LADD PLACE SUBDIVISION, FIRST ADDITION, **RESUBDIVISION OF LOT 1**

APPLICATION NUMBER 10 DATE October 20, 2016
 APPLICANT Ladd Place Subdivision, First Addition, Resubdivision of Lot 1
 REQUEST Subdivision

DETAIL SITE PLAN

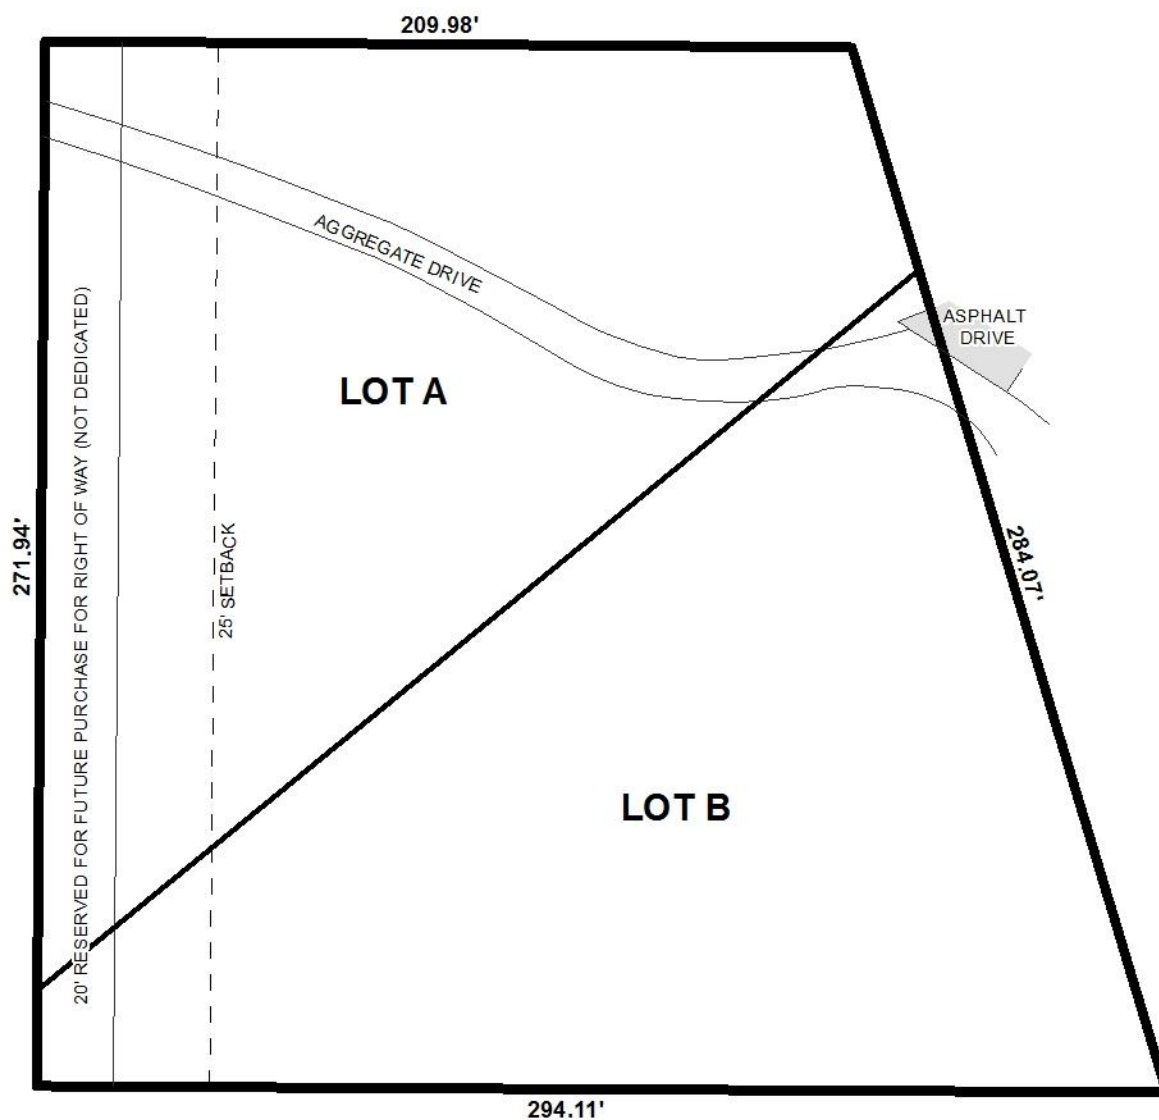
The subject site fronts McGregor Avenue, a major street as illustrated on the Major Street Component of the Comprehensive Plan. As a major street, this street requires a 80' right-of-way width. The right-of-way width is depicted as 60' on the preliminary plat, thus dedication to provide 40' from the centerline of McGregor Avenue should be required.

There is a non-exclusive reciprocal easement indicated on the preliminary plat for ingress to interior Lots 1, 2, and 3 of the original Ladd Place, First Addition subdivision. As Lot 1 is proposed to be subdivided into Lots A and B, access to the easement would appear to only fall to proposed Lot B.

The 25-foot minimum building setback line is depicted on the preliminary plat along McGregor Avenue, and if approved, should be retained on the Final Plat, adjusted for any required dedication.

The proposed lots exceed the 7,200 square foot minimum lot size requirements for lots served by public water and sanitary sewer systems. The lot size information is indicated in both square feet and in acres and should be retained on the Final Plat, if approved.

As proposed, Lot A will have approximately 246 feet of frontage along McGregor Avenue, while Lot B will only have 25 feet of frontage. Due to access management concerns, a note should be placed on the Final Plat stating that Lot A is limited to the existing curb cut to McGregor Avenue and Lot B is limited to the existing curb cut associated with the abutting easement created when the lot was originally platted, with any changes to the size, location and design to be approved by Traffic Engineering and conform to AASHTO standards.

- 1) Dedication to provide 40' from the centerline of McGregor Avenue;
- 2) Retention of the non-exclusive reciprocal easement for ingress to Lots 1, 2, and 3;

- 3) Retention of the 25' minimum building setback line along McGregor Avenue, adjusted for dedication;
- 4) Retention of the lot size information in both square feet and in acres;

- 5) Placement of a note on the Final Plat stating the that Lot A is limited to the existing curb cut to McGregor Avenue and Lot B is limited to the existing curb cut associated with the abutting easement created when the lot was originally platted (as noted in condition #2), with any changes to the size, location and design to be approved by Traffic Engineering and conform to AASHTO standards;
